NONCONFORMANCE - REPORT LOG & STATUS BOOK

1. PROJECT NO. 7220

To J. F. Newgen Date May 13, 1976
 Subject Midland Plant - Units 1 & 2 From R. L. Castleberry
 Job 7220
 Air-Quenched Stainless Steel Piping Of Engineering
 File: 0274, 0545 w/a
 Copies to J. Connolly w/a At Ann Arbor
 L. Sokol
 T. VanVick w/a

NCR 1-5
PAGE 2 of 2

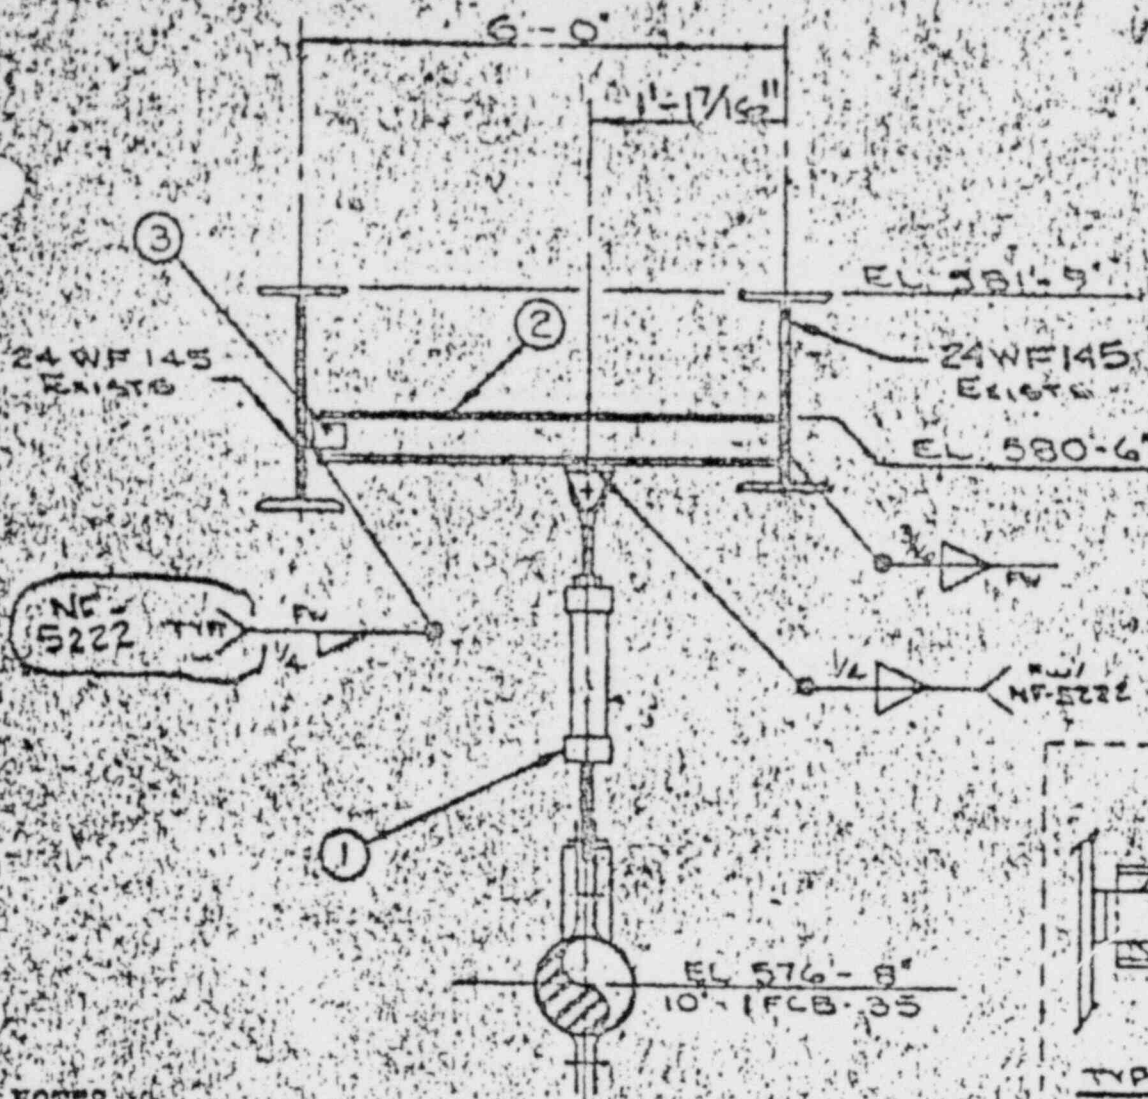
Visual inspection by QC of the weld which connects item #1 to item #2 (Grinnell drawing 1-610-6-3) revealed a complete fillet weld all around item #1. The Project Engineering approved drawing calls for a fillet weld only on two (2) sides of item #1. Reference attached drawing. Q Number is 4.102

ENG. AGREES WITH THE FIELD DISPOSITION TO "USE AS IS." THE EXTRA FILLET WELD ONLY ADDS ADDITIONAL LOAD CARRYING CAPACITY & GIVES A HIGHER SAFETY FACTOR AT THIS JUNCT'N.

5.6 LINE WALL, WEST FACE
(LOOKING EAST)

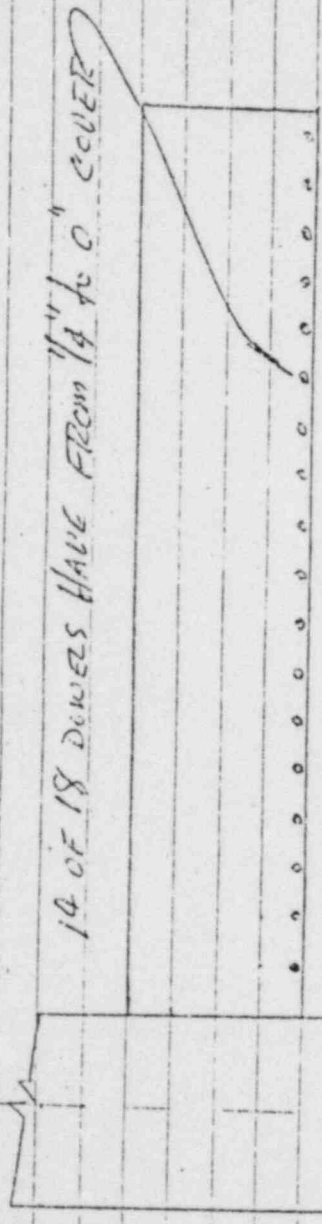
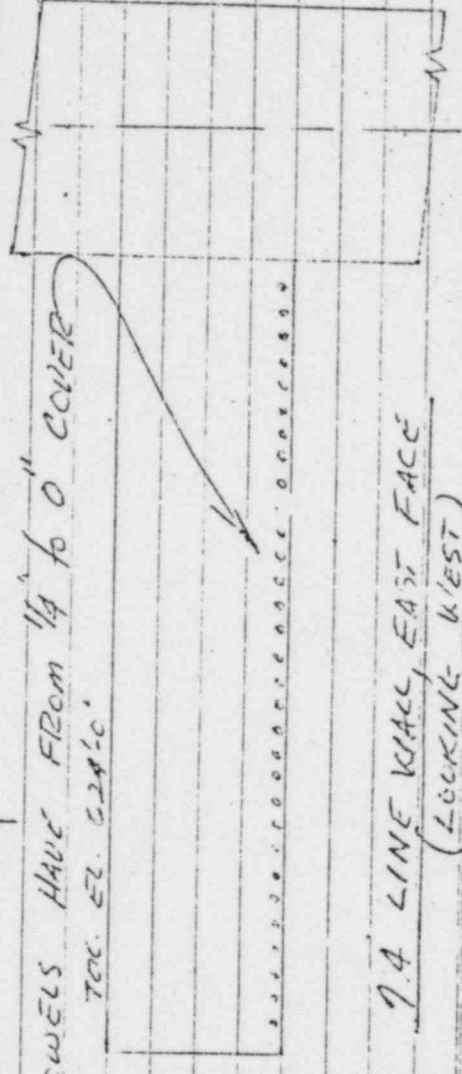
19. NONCONFORMING CONDITION: Drawing 7220-C-140 (Q), Rev. 8 general note 16 states in part, "... in no case shall the tolerance on cover exceed minus one-third of the clear cover stipulated on the design drawings or in the specification." Contrary to the above bottom slab dowels along 5.6 line ^{7-4 line} between C and D line, top of concrete Elev. 624'-0", exceed the allowable tolerance, see Page 2 for existing location. Nonconformance noted during routine QC surveillance. Q-List #1.203. 2 Hold Tags applied.

5.6 LINE WALL, WEST FACE
(LOOKING EAST)

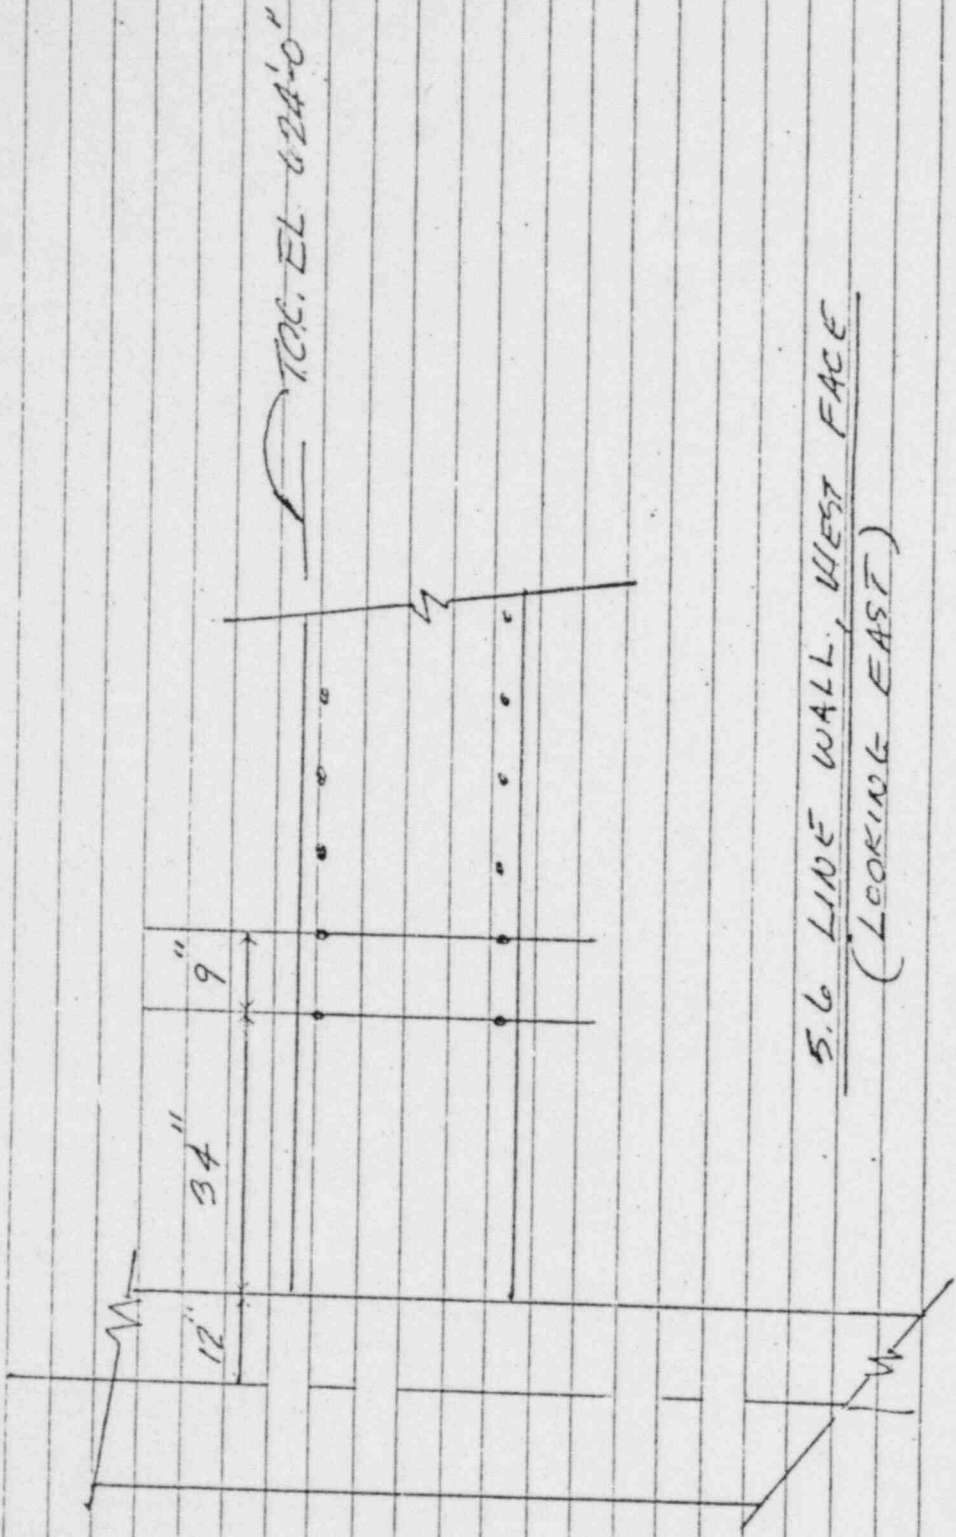
15. NONCONFORMING CONDITION:		Drawing 7220-C-202, Rev. 5 General Note #5 states "Slab dowels to match slab reinforcing unless otherwise noted." Drawing 7220-C-288 (Q), Rev. 4, indicates 12" spacing for slab reinforcing. Contrary to the above, the first top and bottom dowels are located 34" from the face of the wall. See Page 2 for sketch of existing dowel location. Nonconformance noted during routine QC surveillance. Q-List #1.203. One Hold Tag applied.

G-LINE WALL SOUTH FACE
(LOOKING NORTH)

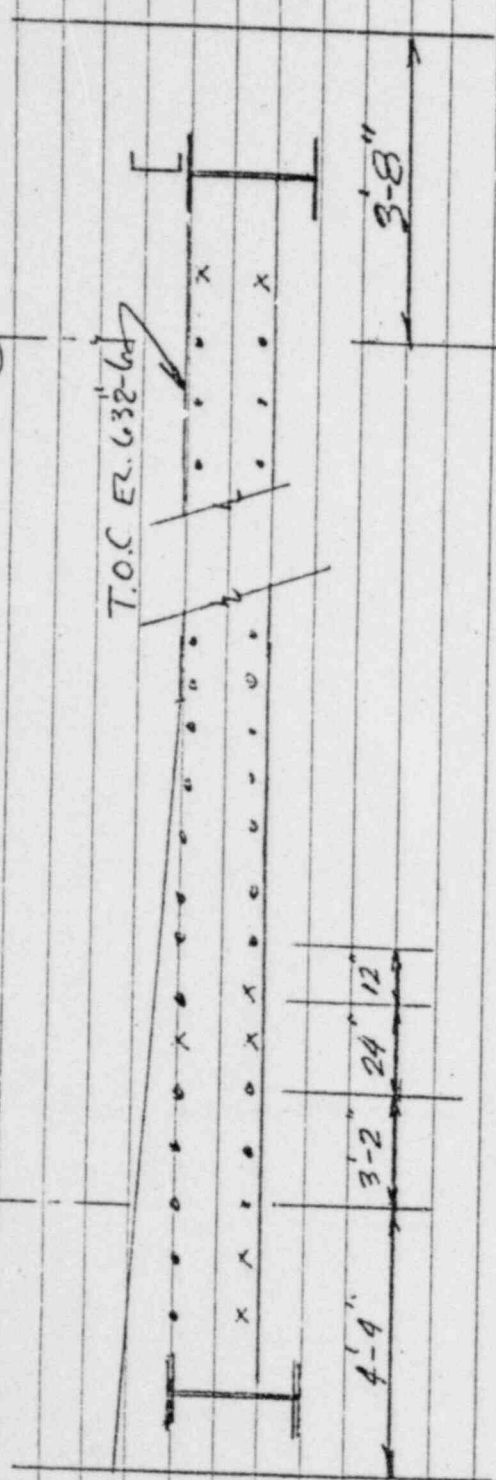
19. NONCONFORMING CONDITION: Drawing 7220-C-202 Rev. 5 general note 5 states "Slab dowels to match slab reinforcing unless otherwise noted." And drawing 7220-C-214 (Q) Rev. 3 indicates 12" spacing for slab reinforcing. Contrary to the above, slab dowels do not match slab reinforcing in three (3) areas along G-line between 5.6 line and 7.4 line at El. 632'6". See page 2 for sketch of existing dowel locations. Nonconformance noted during routine QC surveillance. "Q" list number 1.203. Two hold tags applied.

NDE REPORT NO. 1662

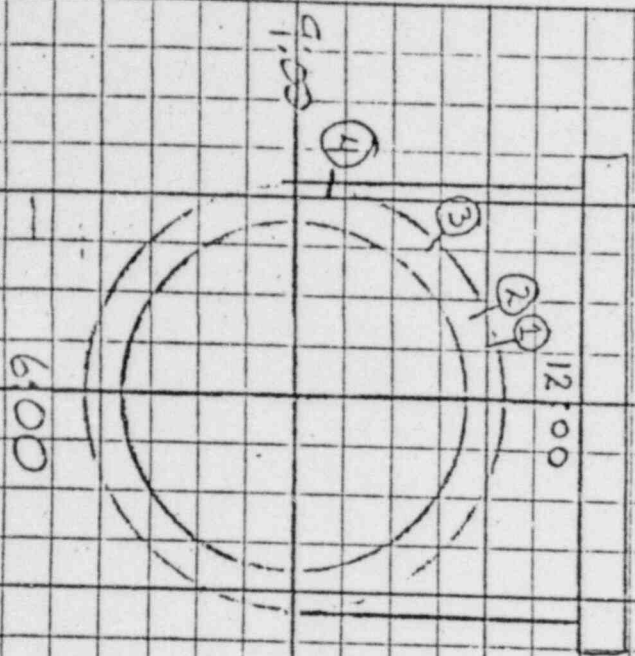
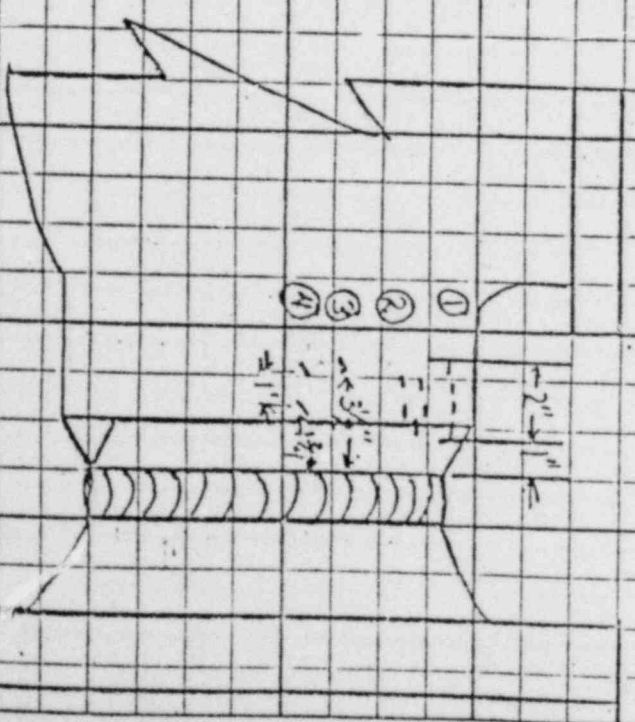
19. NONCONFORMING CONDITION: During a Quality Control required Magnetic Particle inspection of M-613, Sheet 8, Field Weld #8, linear indications were found in the valve body adjacent to the field weld. Reference Nondestructive Examination Report #1662, attached for locations. 'C' number 4.164. One Hold Tag Applied
